# Access Compliance Report

## Public Rights-of-Way

### (Curb Ramps)

Intersection ID: 5579	Main Street: FALLS_BRANCH_LN	Cross Street: GRAYS_CREEK_LN	Location: S
ADA ID: EE0A001651FC	Ramp Type: PerpDiag	Initial Pass/Fail: Fail	Overall Compliance: No
Severity Score: 8.75			
Codes/Mitigation Info/Possible Solution		Field Measurements/Component Compliance

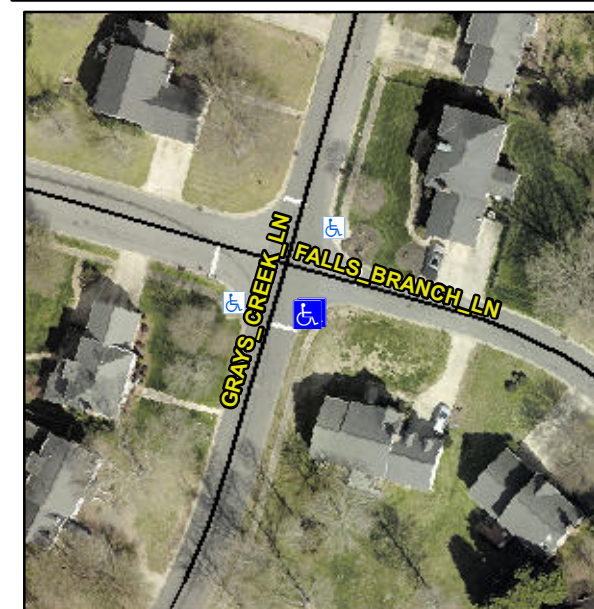
**Not Found, R304.5.1**

Compliance	Description	Data	Compliance	Description	Data
N/A	Ramp Length (in)	49.0	Yes	Ramp Slope (%)	7.4
No	Ramp Width (in)	47.5	Yes	Ramp XSlope (%)	1.0
N/A	Flare Type LT	N/A	N/A	Flare Type RT	N/A
N/A	Flare Slope LT (%)	N/A	N/A	Flare Slope RT (%)	N/A
N/A	Flare Traversable LT?	N/A	N/A	Flare Traversable RT?	N/A
N/A	Landing Length (in)	N/A	N/A	DWS Provided?	N/A
N/A	Landing Width (in)	N/A	N/A	DWS Contrast?	N/A
N/A	Landing Slope (%)	N/A	N/A	DWS Length (in)	N/A
N/A	Landing X Slope (%)	N/A	N/A	DWS Full Width?	N/A
N/A	Landing Curb? (Y/N)	N/A	N/A	DWS Offset (in)	N/A
N/A	Shared Landing?	N/A			
N/A	Gutter Ponding?	N/A	N/A	Gutter Slope (%)	N/A
N/A	Gutter Lip Ht (in)	N/A	N/A	Gutter X Slope (%)	N/A
N/A	Painted X Walk1?	No	N/A	Painted X Walk2?	No
	X Walk 1 Direction	To NE		X Walk 2 Direction	To NW
N/A	X Walk 1 Width (in)	N/A	N/A	X Walk 2 Width (in)	N/A
	X Walk 1 Slope (%)	3.0		X Walk 2 Slope (%)	4.3
	X Walk 1 X Slope (%)	5.2		X Walk 2 X Slope (%)	2.6

N/A	Ramp inside XWalk1?	N/A	N/A	Ramp inside XWalk2?	N/A
	Road Slope (%)	2.2	N/A	Clear Space?	N/A
	Road X Slope (%)	9.0	N/A	Clear Space to XWalk (in)	N/A
N/A	Any Obstructions?	N/A	N/A	Storm Grate/Utility Hazard?	N/A
	Obstruction Type			Storm Grate/Utility Type	
		N/A			N/A
			Yes	Surface Condition? (G/P)	Good

**Remove & Replace Curb Ramp With Two New Directional Ramps or Equivalent.**
